TVA-BFN-TS-430

**BROWNS FERRY NUCLEAR PLANT (BFN) UNIT 1 - TECHNICAL  
SPECIFICATIONS (TS) CHANGE 430 - POWER RANGE NEUTRON MONITOR  
UPGRADE WITH IMPLEMENTATION OF AVERAGE POWER RANGE MONITOR AND  
ROD BLOCK MONITOR TECHNICAL SPECIFICATION IMPROVEMENTS AND  
MAXIMUM EXTENDED LOAD LINE LIMIT ANALYSES**

#### TVA EVALUATION OF PROPOSED CHANGE

Figure 3.4.1-1  
THERMAL POWER VERSUS CORE FLOW STABILITY REGIONS

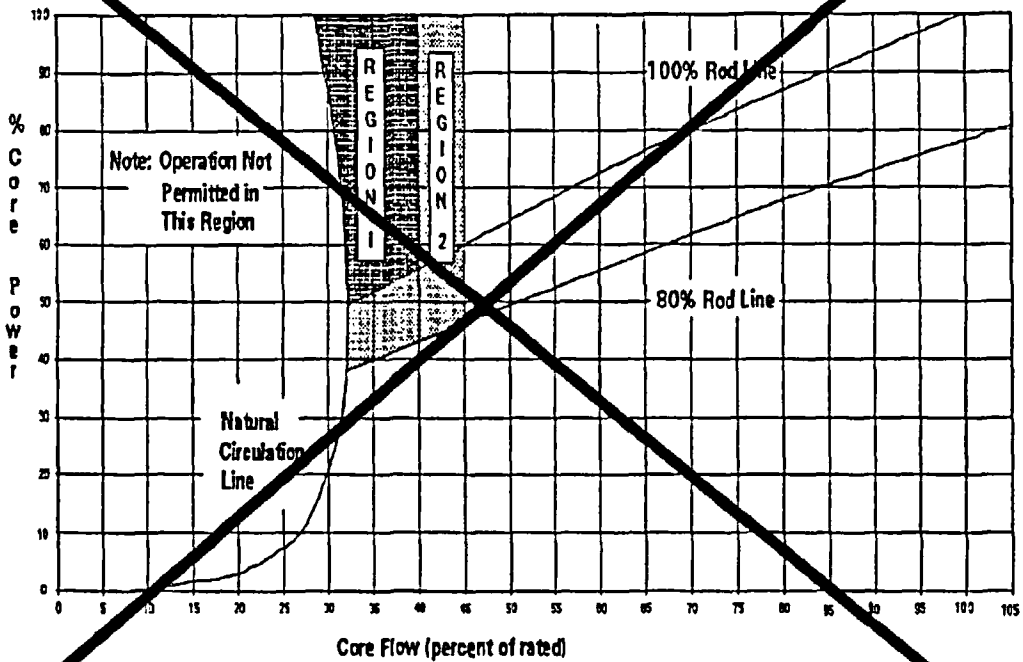
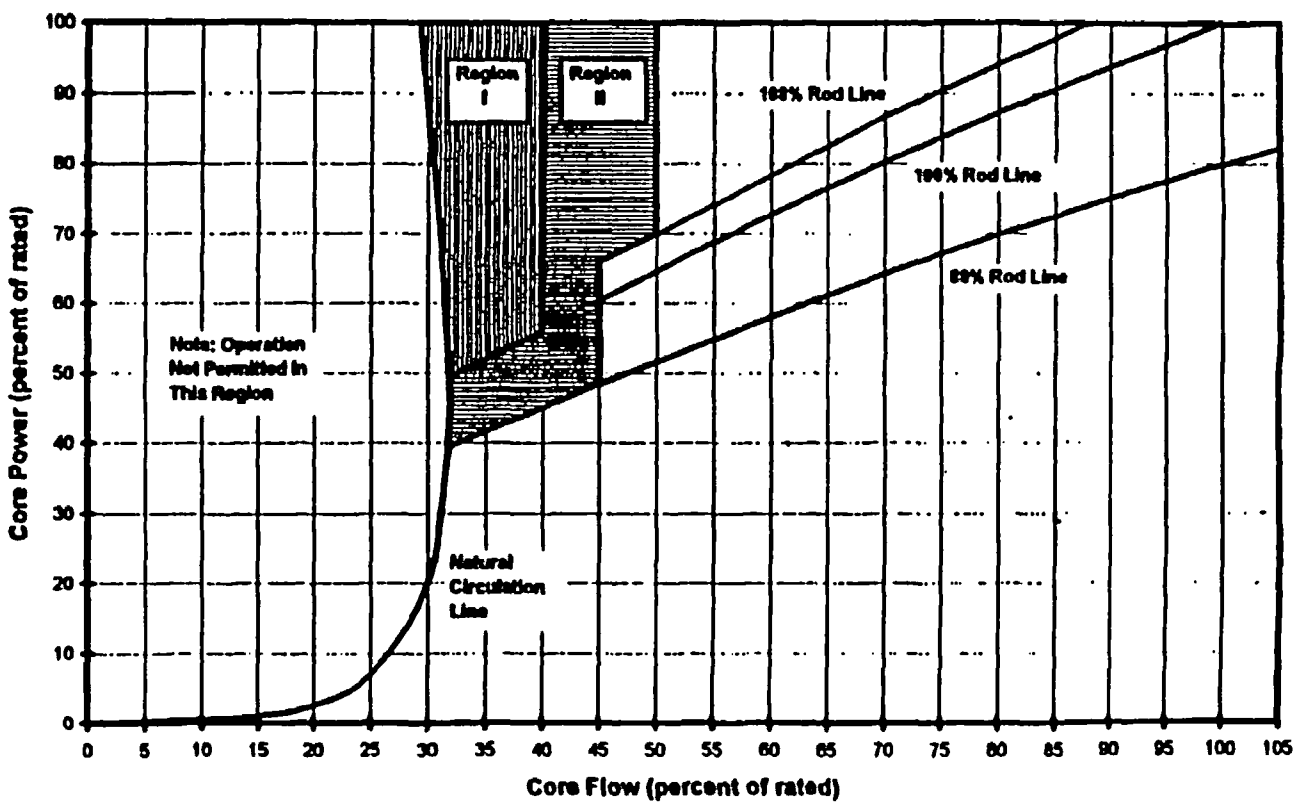
Figure 3.4.1-1 is modified to expand the Region II area to include the power/flow map area between 45% and 50% core flow, and above the 108% rod line. Also, the figure is reformatted to improve readability.

Changes 15 and 16 - Figure 3.4.1-1, Thermal Power Versus Core Flow Stability Regions, is modified to expand Region II to include the power/flow map segment between 45% and 50% core flow, and above the 108% rod line. This change is made to maintain compatibility with the improved Boiling Water Reactor Owners' Group (BWROG) Guidelines for Stability Interim Corrective Actions for plants operating under a MELLL expanded power/flow map. Prior to implementation of MELLL, the existing APRM rod blocks and load line limitations physically restricted reactor entry in this area. With the MELLL expanded power/flow map and increased rod block lines, it becomes possible to operate in this area. The BWROG Guidelines, however, classify this area as a Region II restricted area, and to stay consistent with BFN's commitments to implement the BWROG Stability Guidelines, the TS Figure is modified to include this power/flow map region as Region II area. SR 3.4.1.2 is also modified to increase the SR domain from 45% to 50% core flow to match the change in the Figure 3.4.1-1 core flow value.

REPLACE  
WITH  
ATTACHED  
FIGURE
